CAMPAIGN 5559 - Service Campaign

Model: Fiat Ducato with 2.3 JTD 130 HP E5 engine

- engine ECU
- engine compartment layout

Fig. 1

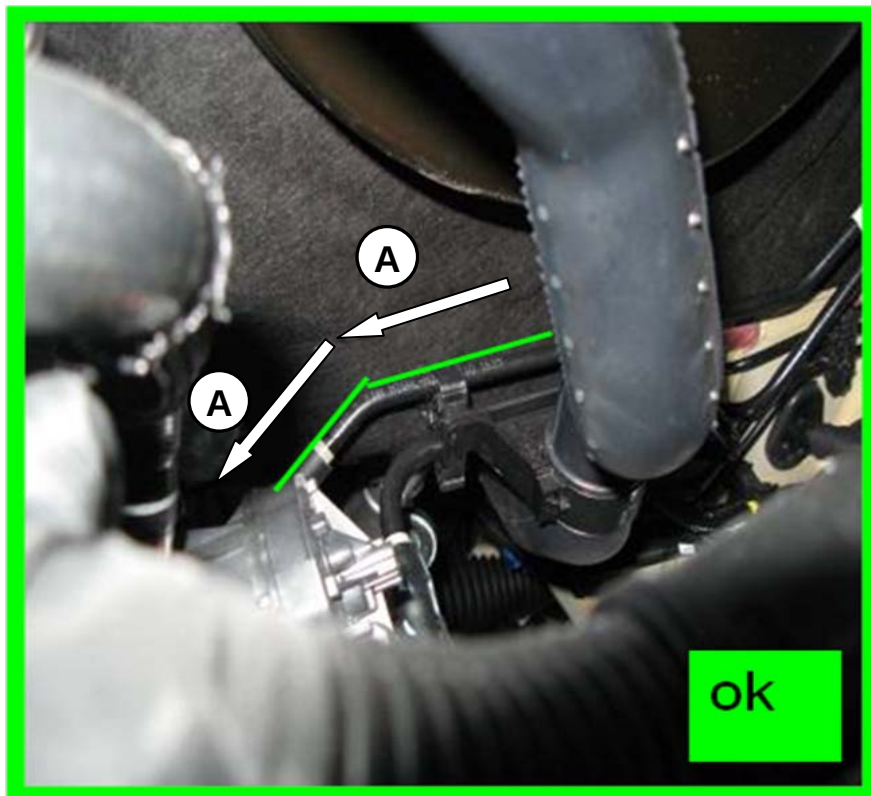
- Identify the supply pipe from fuel filter to duplex pipe.
- Check the path of the pipe.
- If the path of the pipe is as shown (A) following the direction of the arrows (Fig.1) with the bend of the pipe downwards, the vehicle is compliant.

Fig. 2

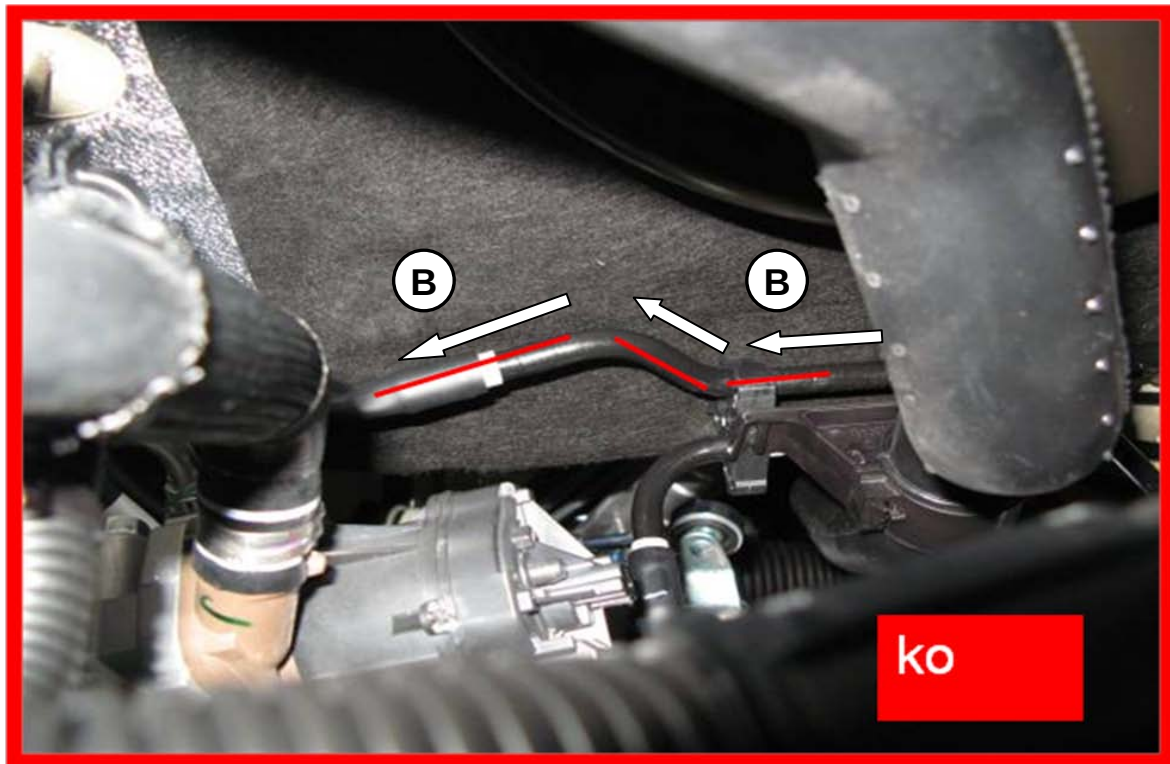
- If the path of the pipe is as shown (B) following the direction of the arrows (Fig. 2), with the bend of the pipe upwards, or in any case other than shown in Fig. 1, the vehicle is not compliant and the pipe must be replaced proceeding as follows:
- Replace the pipe (see Part&Service availability), as described in operation 1040B40 of the Service Manual.
